**Fraser Planning Commission Agenda
City Council Chambers
33000 Garfield, Fraser, MI 48026
Wednesday, November 6, 2024 @ 7:00 p.m.**

Site Plan Review Summary

Site Plan Dated 8/12/2024
City of Fraser, Michigan

Reference: Site Plan Review

MISTER CAR WASH
STORE # MI 1454 FRASER
SITE PLANS
PRELIMINARY UTILITY PLAN

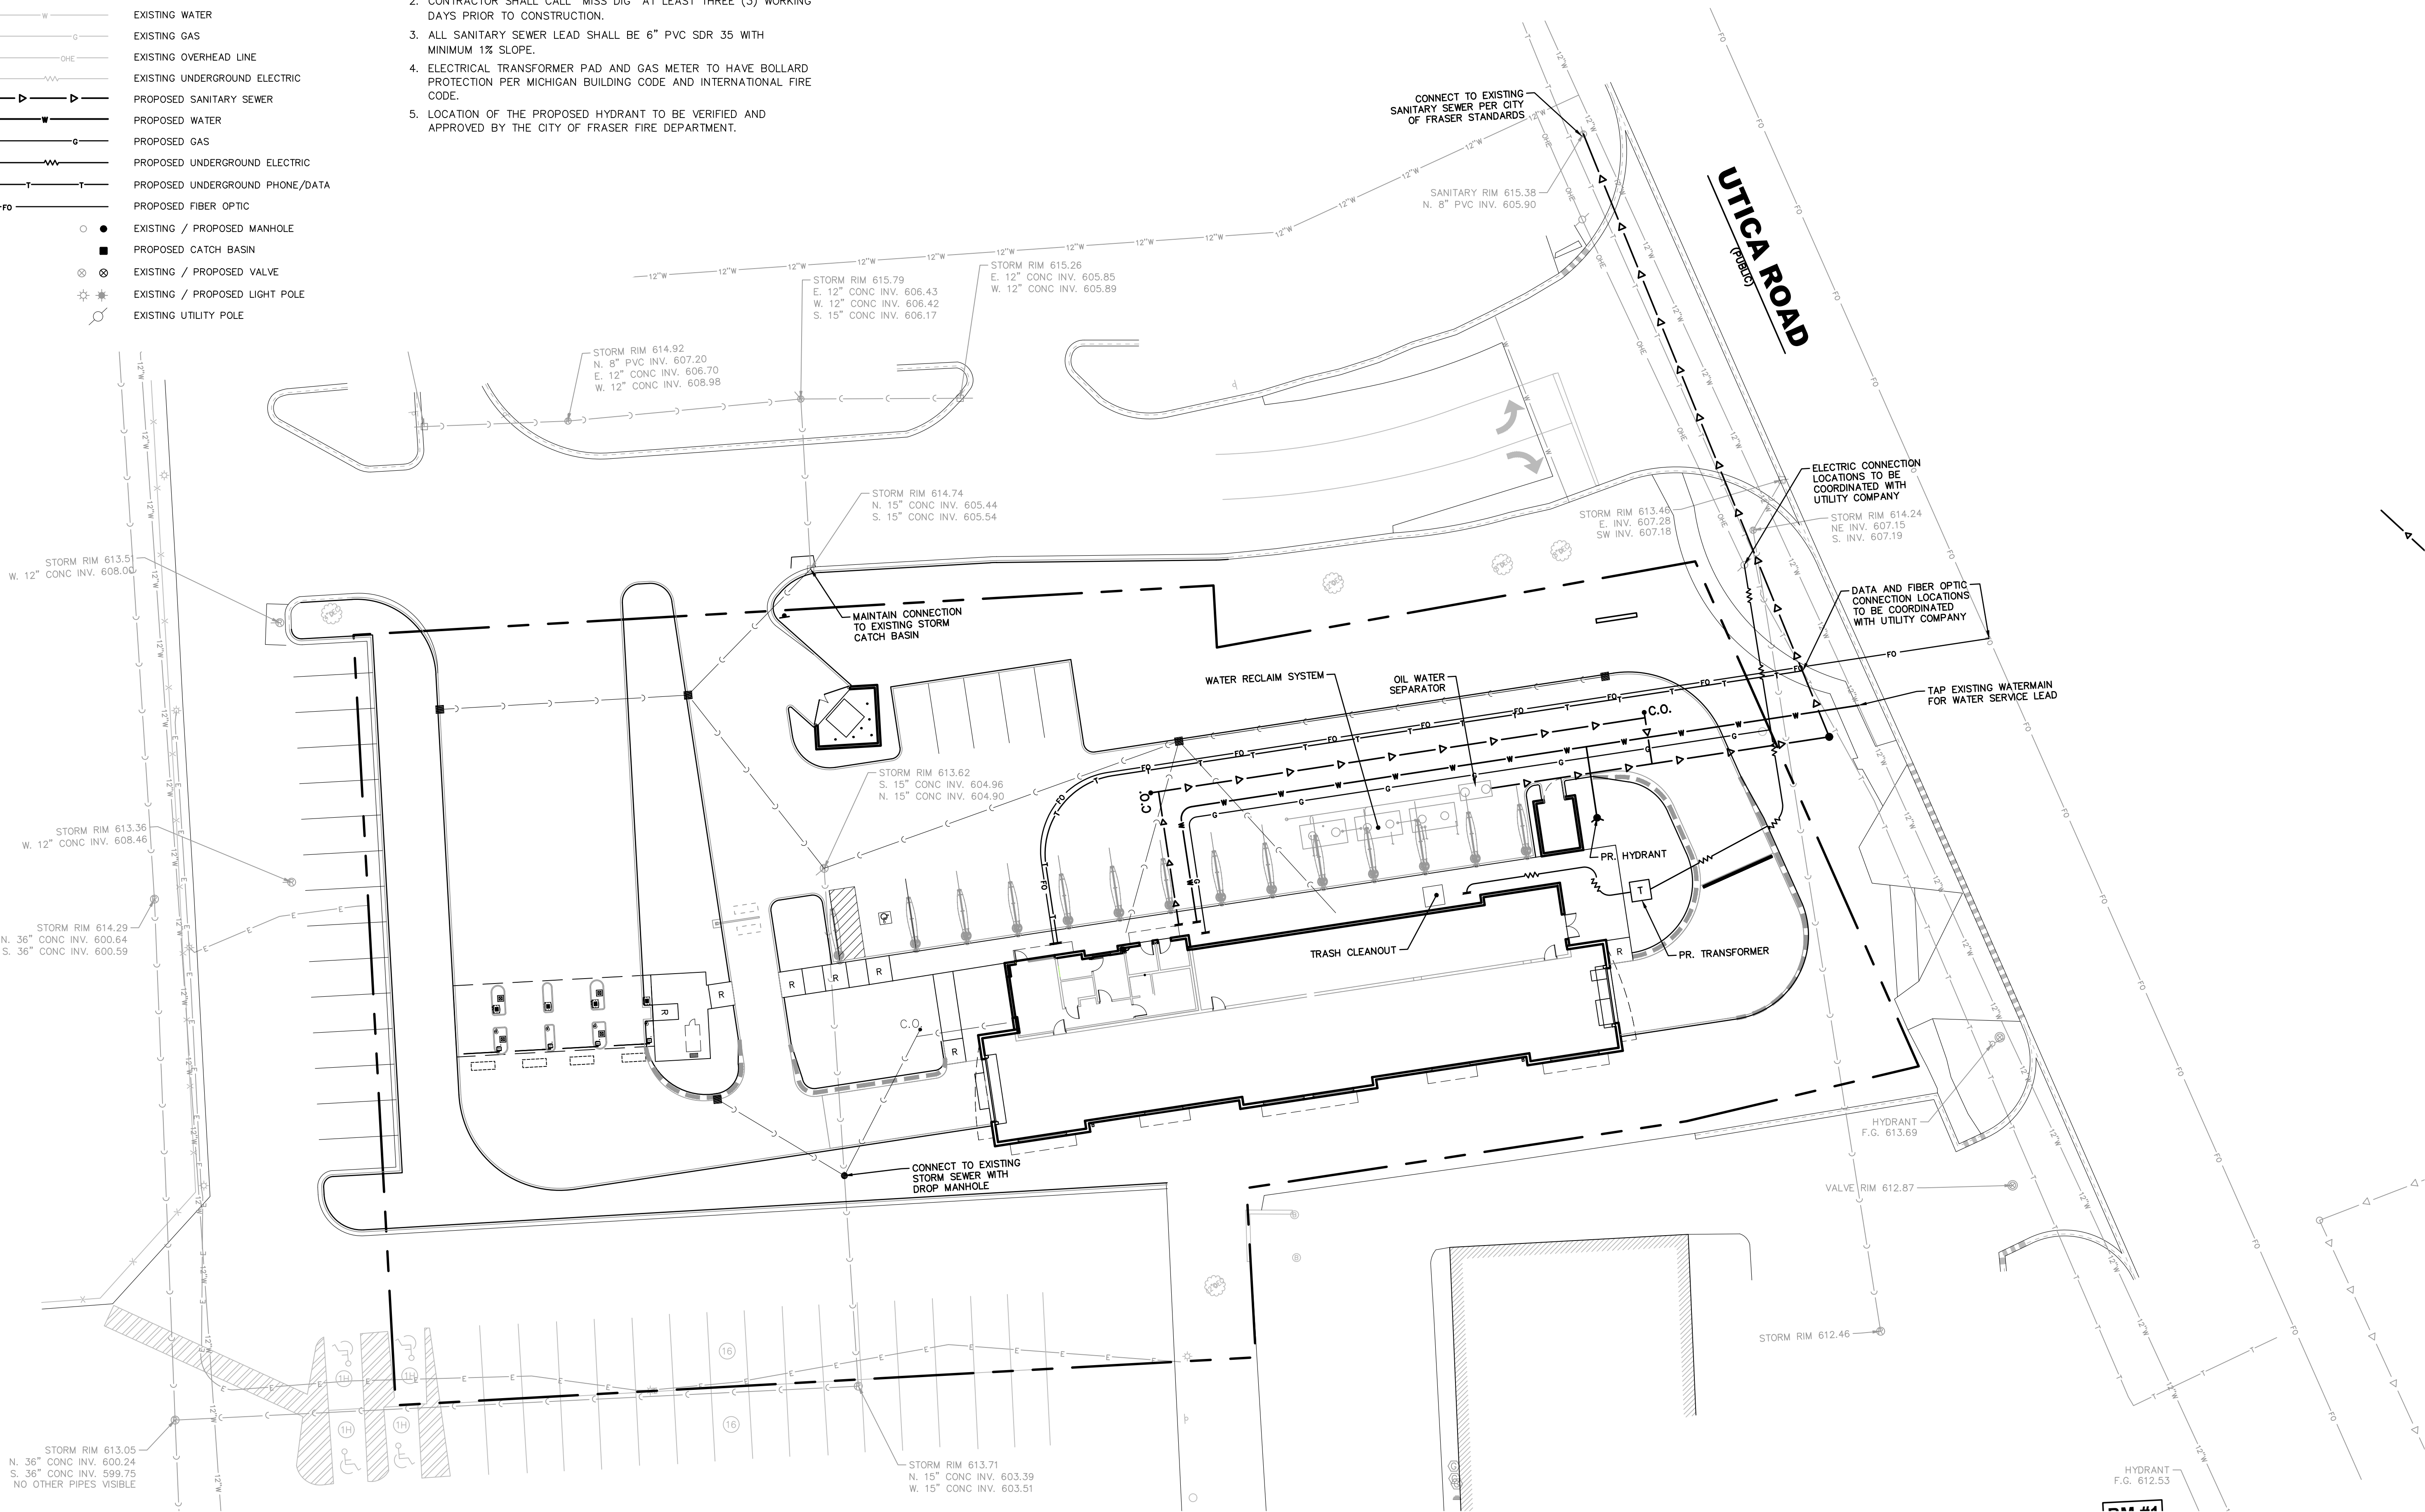
1. An existing 12" water main is located under the southbound lanes Utica Road and is available for service to the site. Site plan should be updated to reflect correct location.

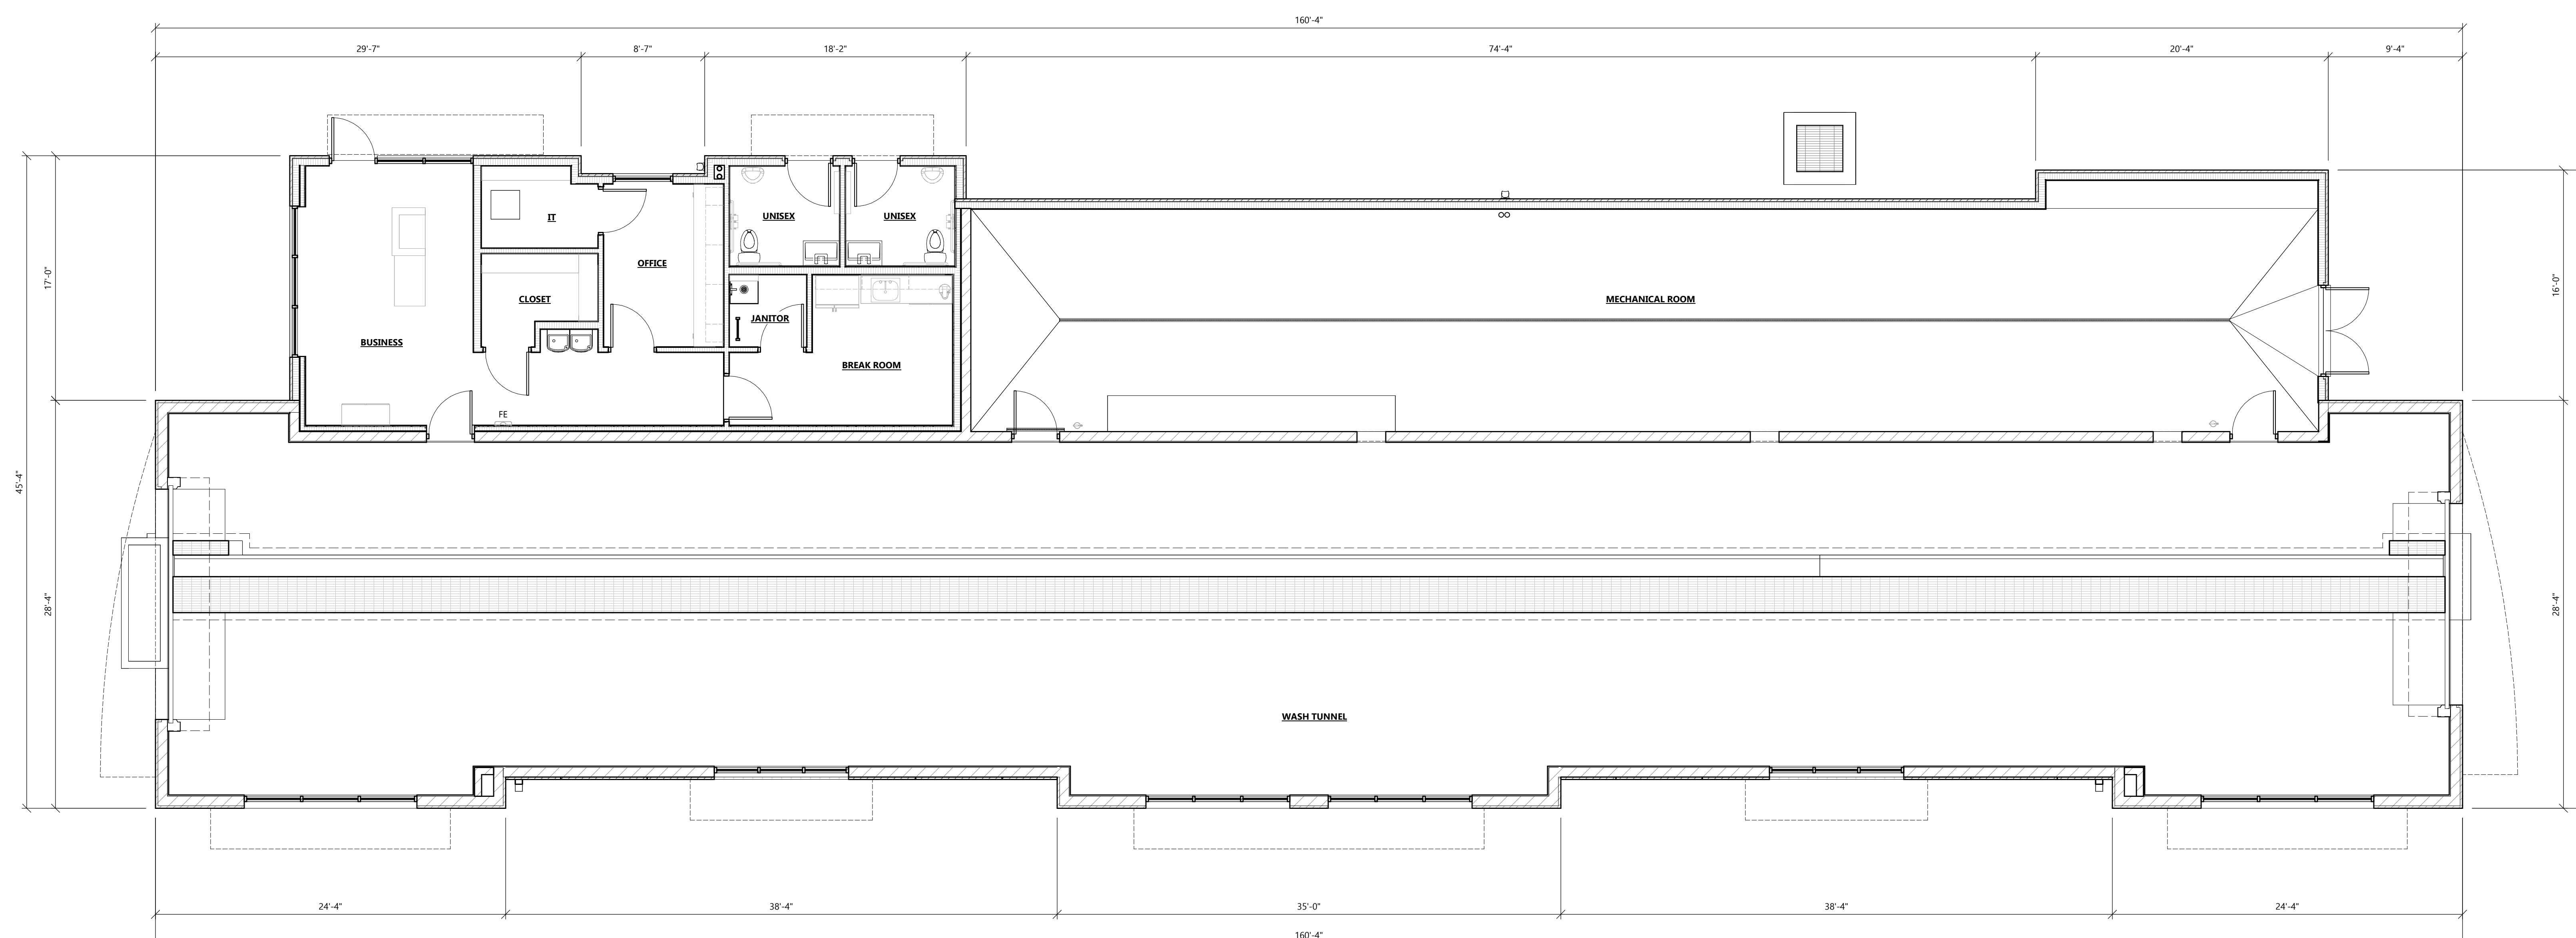
****Note the site plan elevations on Sheet PRE-1 indicate the building is 135 feet tall. We believe this to be an error and an extra "1" was added to each height based upon the seemingly correct elevation for the West Entrance. Given this we assume the proposed height is 35 feet, which exceeds the required height permitted.**

1. *The building height needs to be 30 ft or less.*
2. *The proposed property line needs to be adjusted so that it does not remove required Meijer parking spaces, or a variance for the extra parking needs to be approved on the Meijer site.*
